**DEADLINE 7 RESPONSE**  
**KENT DOWNS AONB RESPONSE TO**  
**National Highways Deadline 6 Submission**  
**Response to Action Point 6 from ISH 9**  
**9.157 Kent Downs AONB and Utilities Works**

**Interested party Ref no: 20035310**

Figure 1 Tree Removal and Retention Plan, taken from 6.2 Environmental Statement Figures Figure 7.24.

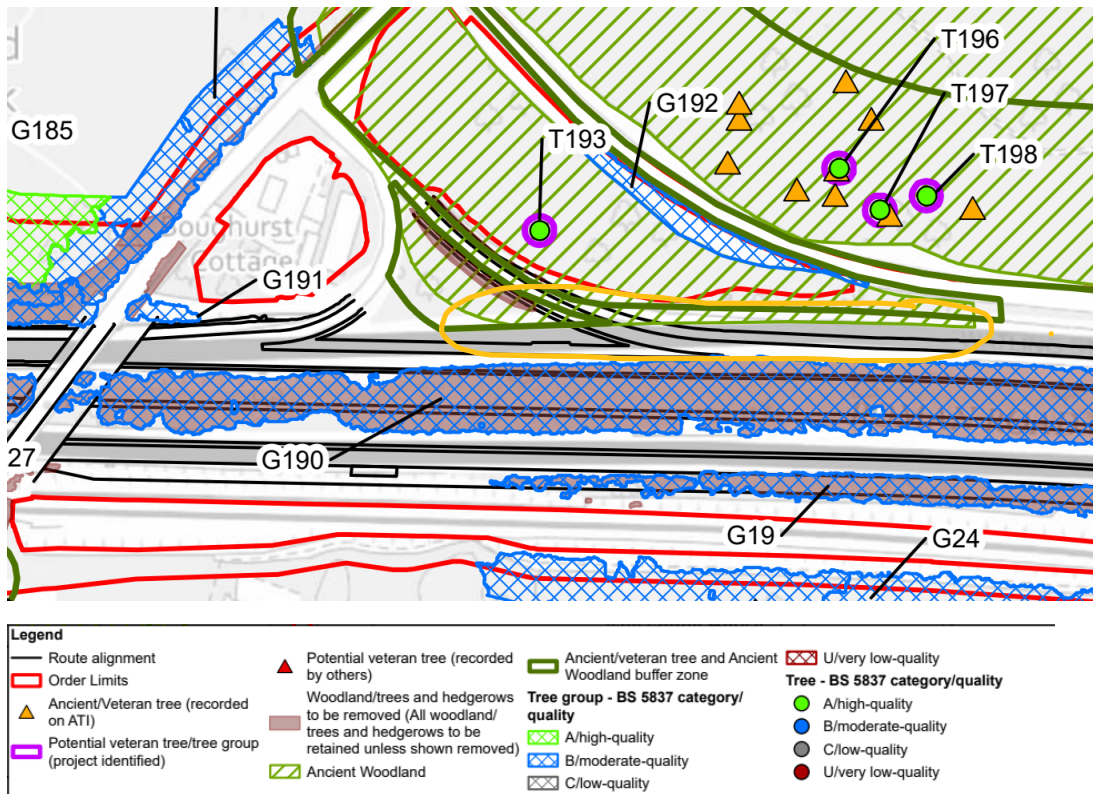
The area of woodland proposed to be removed is provided in another of the Applicant's submission document, see Figure 1 below ( 6.2 Environmental Statement Figures Figure 7.24 - Tree Removal and Retention Plan [link](#)), however this does not have the utilities diversions overlaid. Furthermore, this plan does not appear to correspond with Figure 8.33 Ancient Woodland Impacts, Page 2 of 6 (Doc 6.2 Environmental Statement) [link](#)), - see Figure 2 below, which shows additional areas of Ancient Woodland to be lost to those shown on the Tree Removal Plan. In addition, the Environmental Masterplan Section 1, Sheet 3, [link](#) , relevant extract shown in Figure 3 below, shows proposed replacement planting (comprising species rich grassland and shrubs with intermittent trees) on the land currently comprising Ancient Woodland (and other woodland not designated as Ancient) to the immediate north of the A2 eastbound on slip from Brewers Road and the southern part of the land locked triangle to the east of The Nook Pet Hotel (Broughurst Cottage), that is not indicated as being removed on the Tree Removal and Retention Plan. These areas are circled in yellow/orange on Figures 1 to 3 below.
